Service Bulletin

Bulletin 2002-28-ABD

SUBJECT: New Honeywell Pilot & Thermopile Assembly in 35 Series Fryers

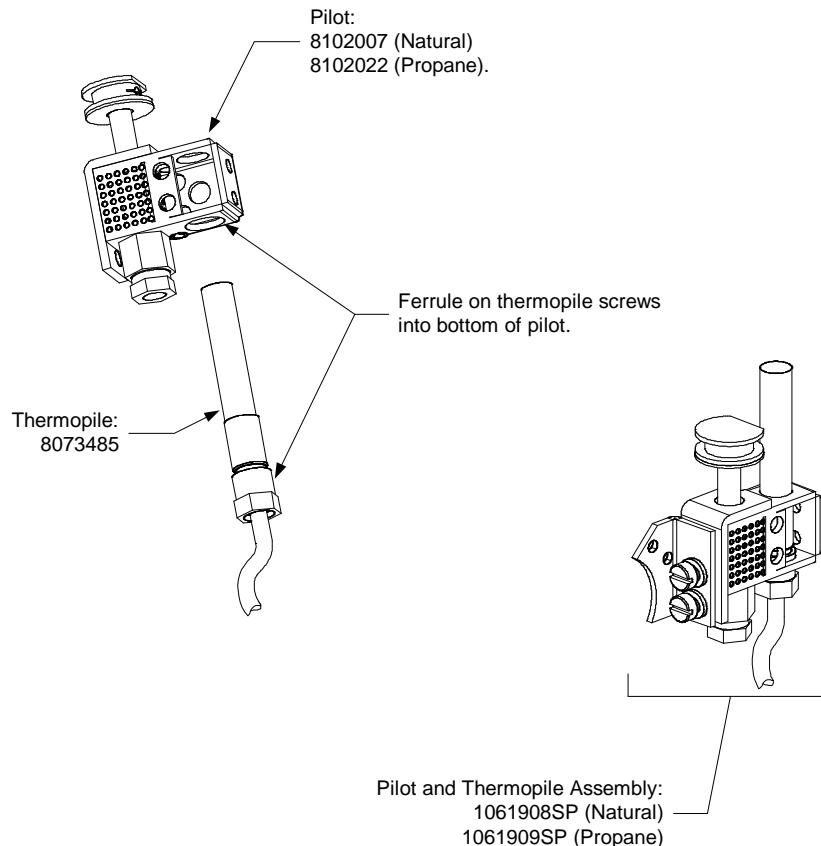
Effective 19 December 2002 a new Honeywell pilot and thermopile assembly is being used on Non-CE 35 Series gas fryers.

The new assembly, illustrated below, mounts to the burner manifold in the same way as the previous assembly, but the components of the new assembly (pilot and thermopile) are not interchangeable with those of the old assembly. List prices for the new parts are: pilot - \$26.00, thermopile - \$22.00, complete assembly with mounting bracket - \$81.00. The components of the old assembly remain available for service.
